Bid Package 1 | Addendum No. 4
for
Construction of
St. Croix County Health Center Additions and Renovation
Project No. 146038

Date: June 24, 2015

SHEET L100 (reissued)

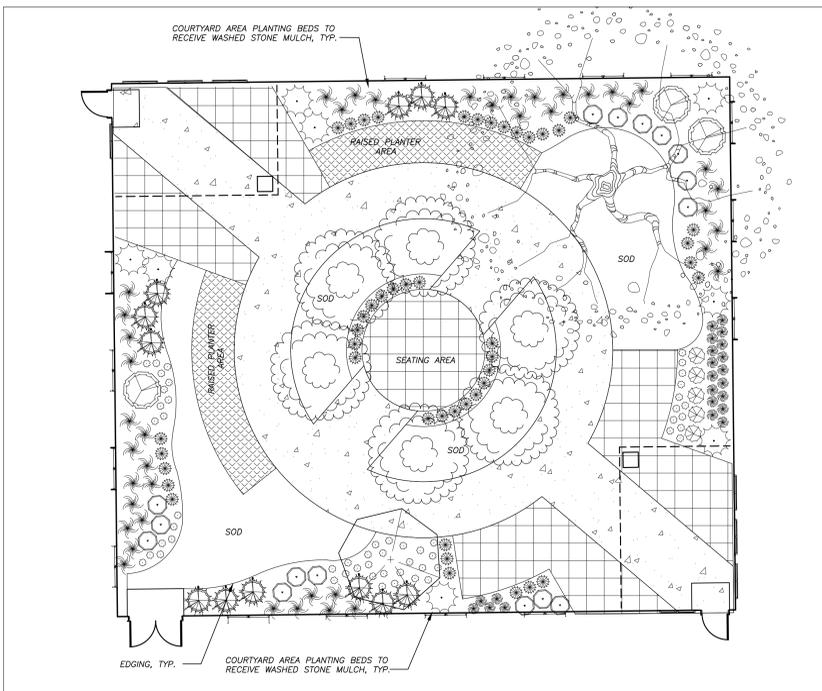
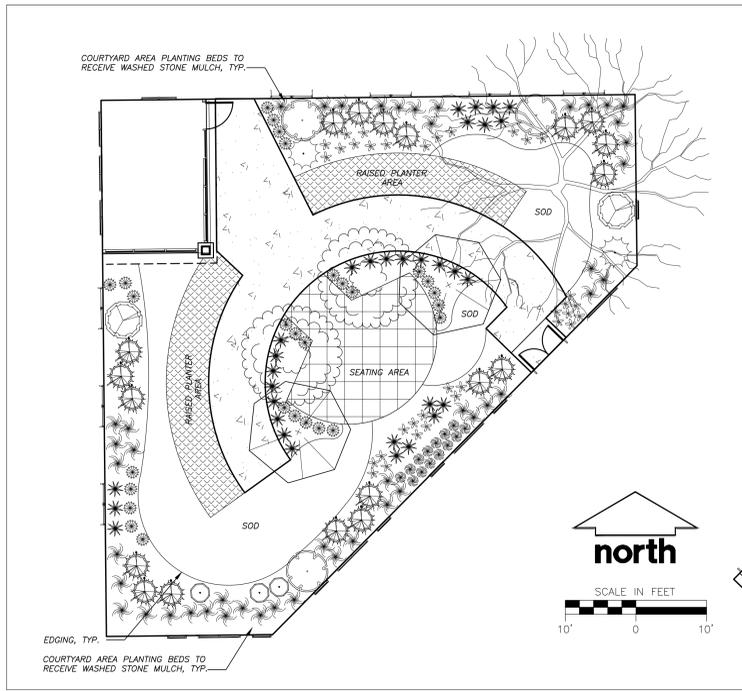
- F. Question: What is the extent of Grass seed vs. sod?
Answer: Only courtyard areas shall receive sod. See sheet L100 and L200 for further clarification.

Add clarification notes showing locations of sod.

SHEET L200(reissued)

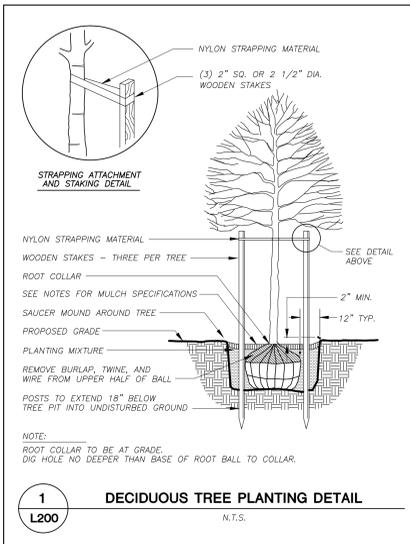
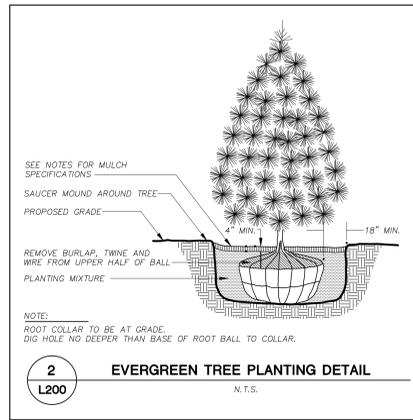
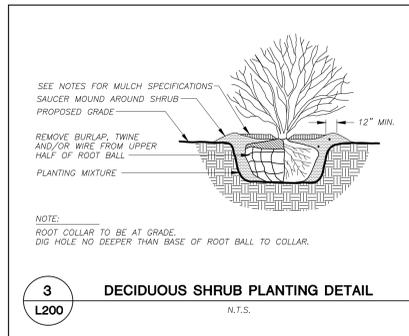
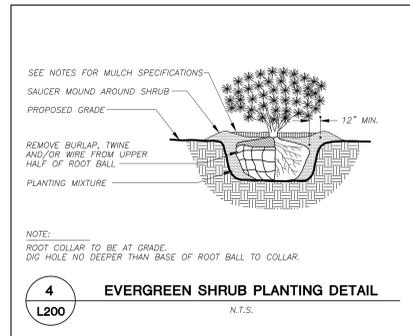
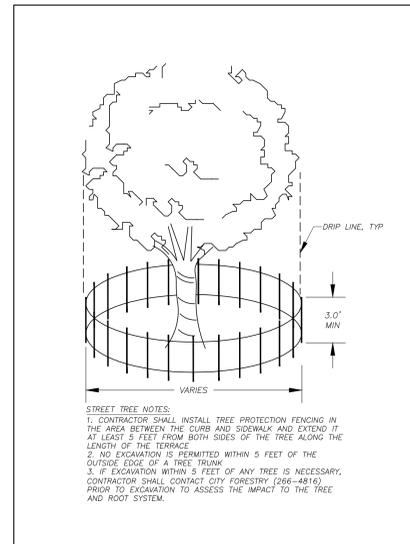
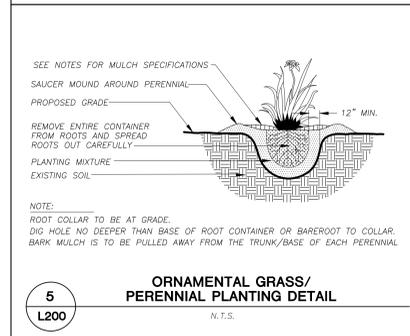
Add note #11 to Landscape Notes and Specifications.
